AMENDMENT #0001

Amendment No. 1

AMENDMENT NO. 1 TO SPECIFICATIONS FOR BEACH EROSION CONTROL AND HURRICANE PROTECTION PROJECT, EAST ROCKAWAY INLET TO ROCKAWAY INLET AND JAMAICA BAY, NEW YORK, BEACH RESTORATION CONTRACT 8

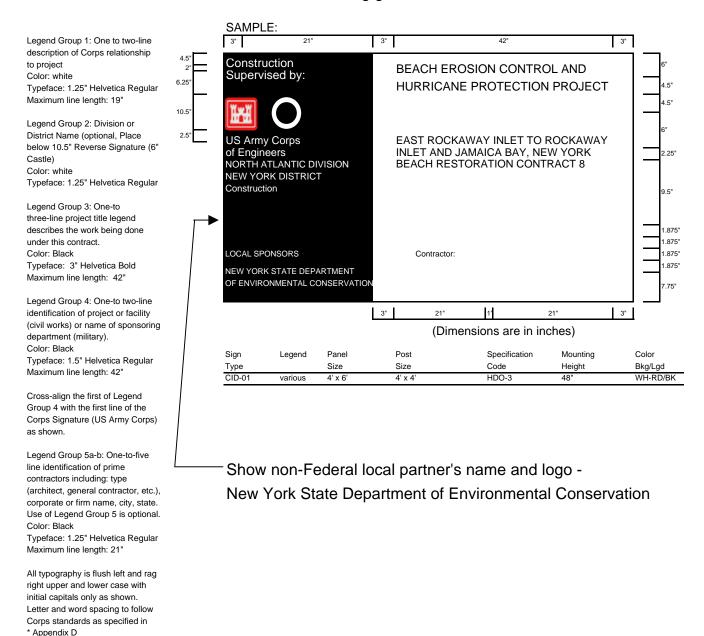
4. Specifications Section 00800, Project Signs: Revised signs to include correct project name and District Engineer's name.
